Exception Request No.: 47
Section: WBR3
Town: Thornton
Highway: US 3 (Tier 2)
Station: 2000+50±
Drawing No.: WBR3 C161
Survey Report Cross Reference No.: WBR3 C157
Exception Type: Crossing Over Existing Drainage Structure

EXCEPTION 47-CROSSING OVER EXISTING UTILITY/DRAINAGE:
NPT WBR3-UNDERGROUND ALIGNMENT
WBR3 SECTION-STA. 2000+50
DATE: 05/20/17

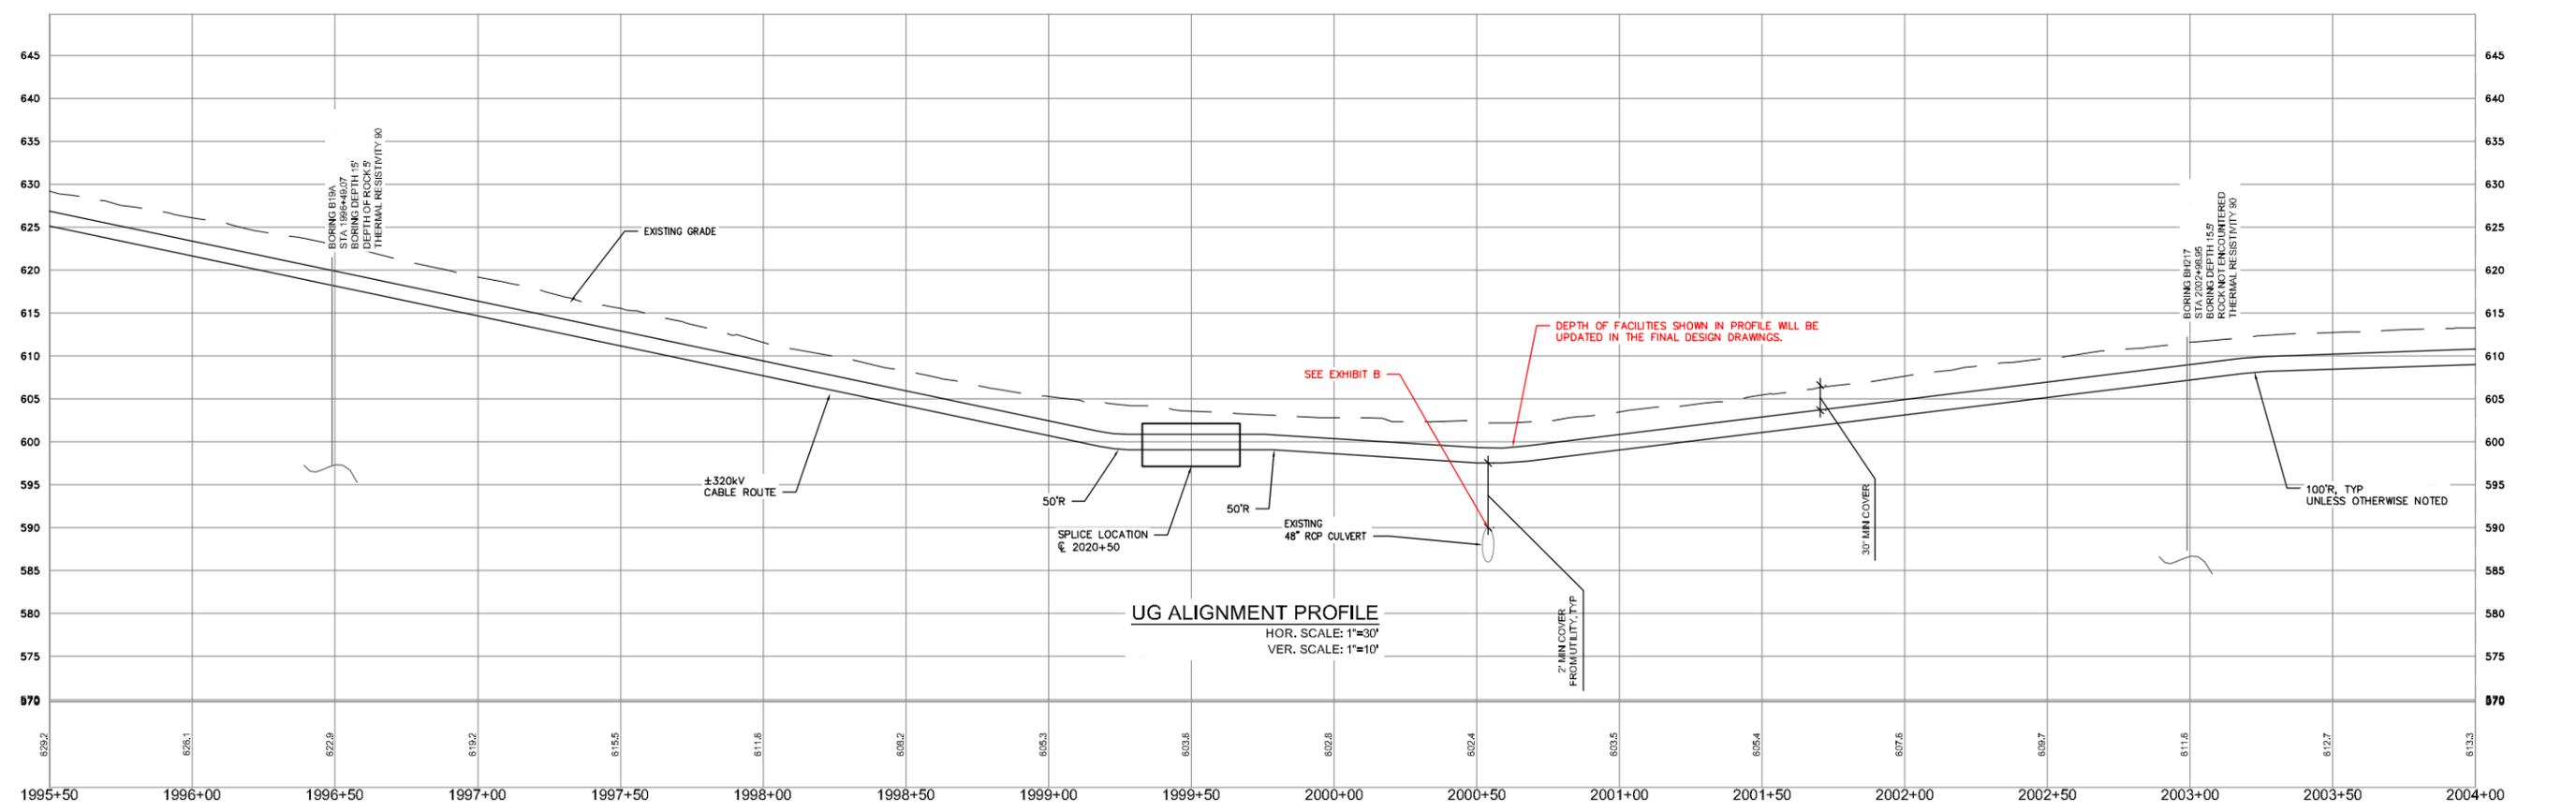
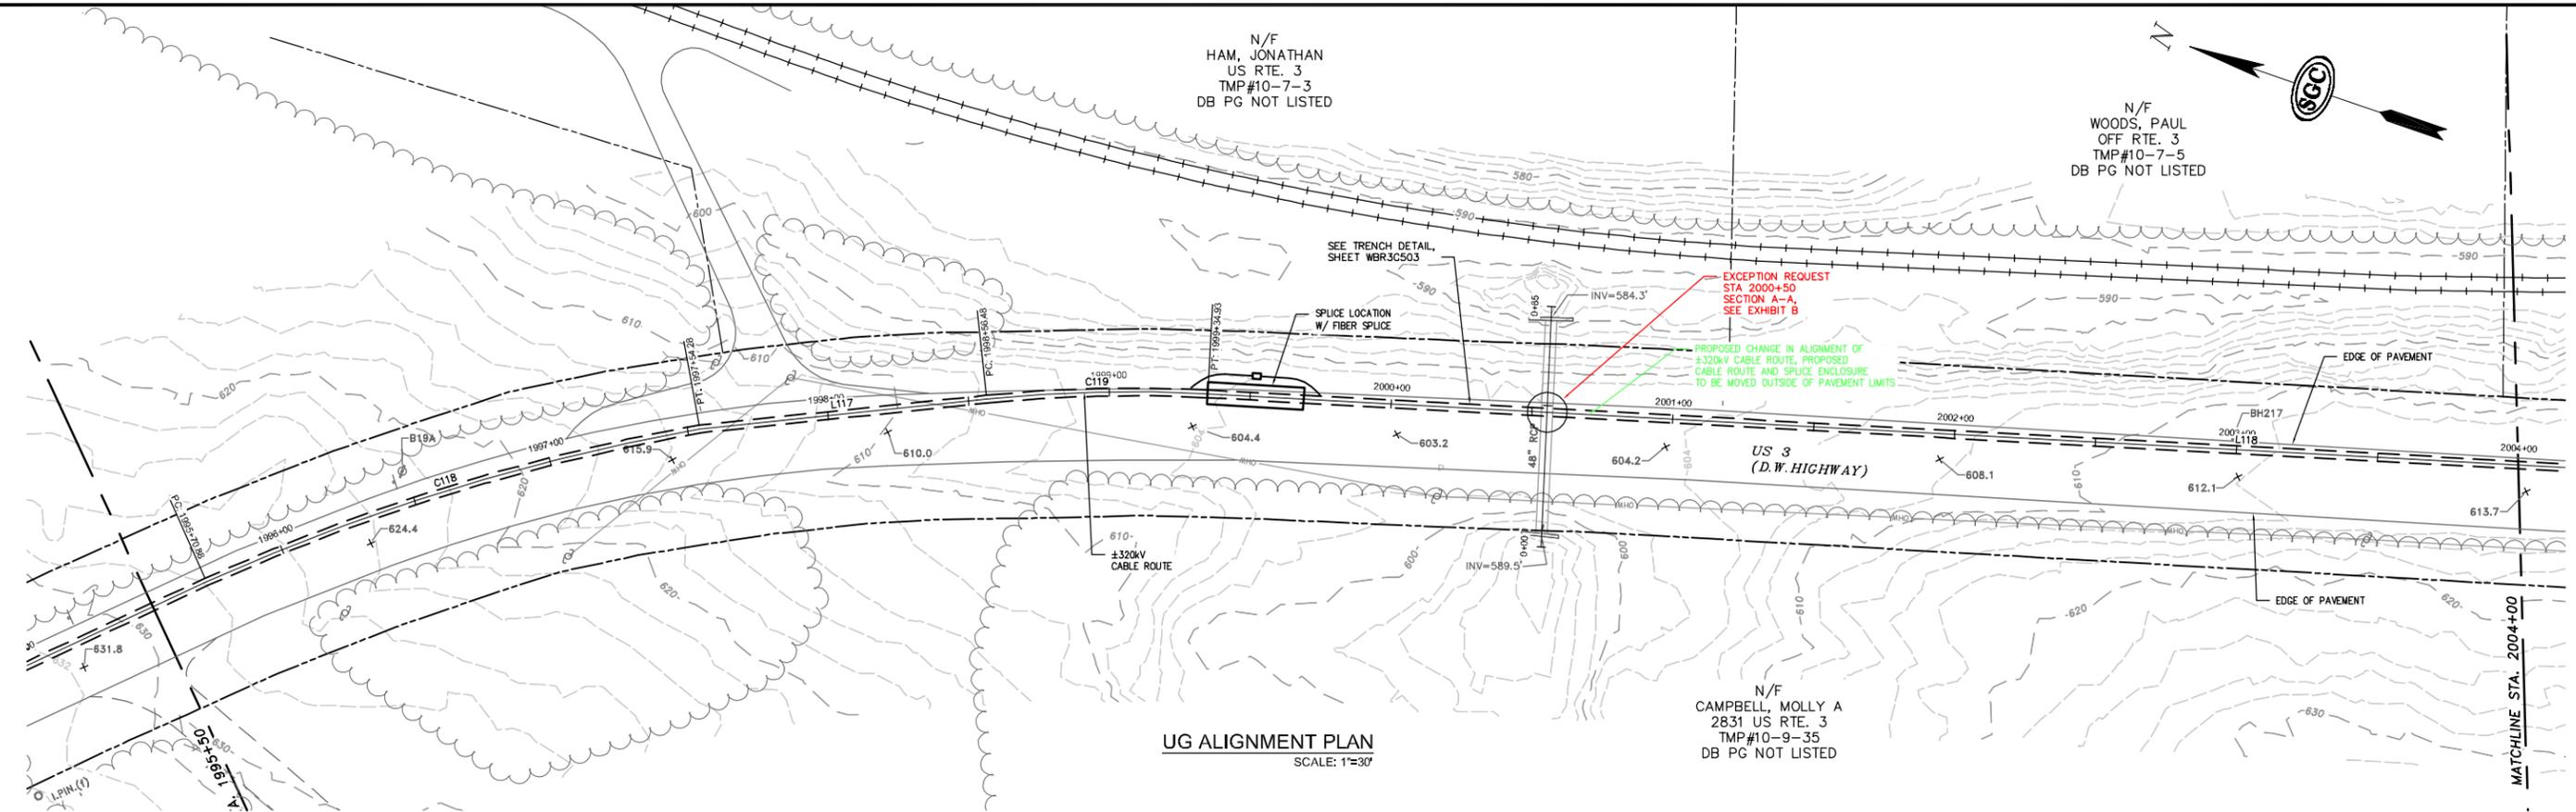
NPT is requesting an exception from the UAM guidelines for crossing above an existing 48--inch RCP culvert on US 3, Daniel Webster Highway at station 2000+50±. There is 12 feet of cover over the culvert. The proposed alignment will be set outside the pavement and over the existing culvert to avoid significant traffic impacts, unreasonable costs associated with a deeper excavation, and increased construction width which will extend the duration of construction and traffic impacts. The attached exhibits have been provided for this location to illustrate the constraints associated with installing the ductbank below the existing culvert.

The vertical positioning of the cable trench is constrained by the depth of the existing culvert (twelve feet to the top of the culvert). (See Exhibits A and B). Crossing under the existing culvert to meet the required 2-foot minimum separation will require a greater separation of the conduits and cable to accommodate shoring and thermal design criteria for the electric cables resulting from the additional depth. This trench width and additional offsets necessary for construction would likely result in significant traffic impacts, including extended duration of construction within roadway to allow for sheeting installation and removal and extensive excavation due to the depth and width of the trench. We estimate that these construction alternatives will add 2-3 weeks to the traffic impacts. Finally, we estimate the increase in cost associated with crossing underneath the culvert would be approximately \$200,000 for this 200-foot section. (See Exhibit C.) Road closures are not needed for the proposed installation, which thereby minimizes traffic impacts and attendant safety issues.

Note: On Exhibit A, the alignment of the ductbank in the area of this exception is shown in the roadway. NPT intends to move the alignment out of the roadway in this area, which will be reflected in the final plan drawings.

At all locations where the new ductbank is constructed over an existing drainage structure or utility, NPT will add rebar to the concrete encasing of the ductbank for a 15-foot section on each side of the crossing to form a 30-foot self-sustaining bridge that will allow for excavation under the duct bank for purposes of future maintenance of existing utilities or drainage structures. In connection with future maintenance activities, especially related to the culvert, NPT will provide any and all required support, including but not limited to, providing crews to assist while work is being conducted in the vicinity of the culvert.
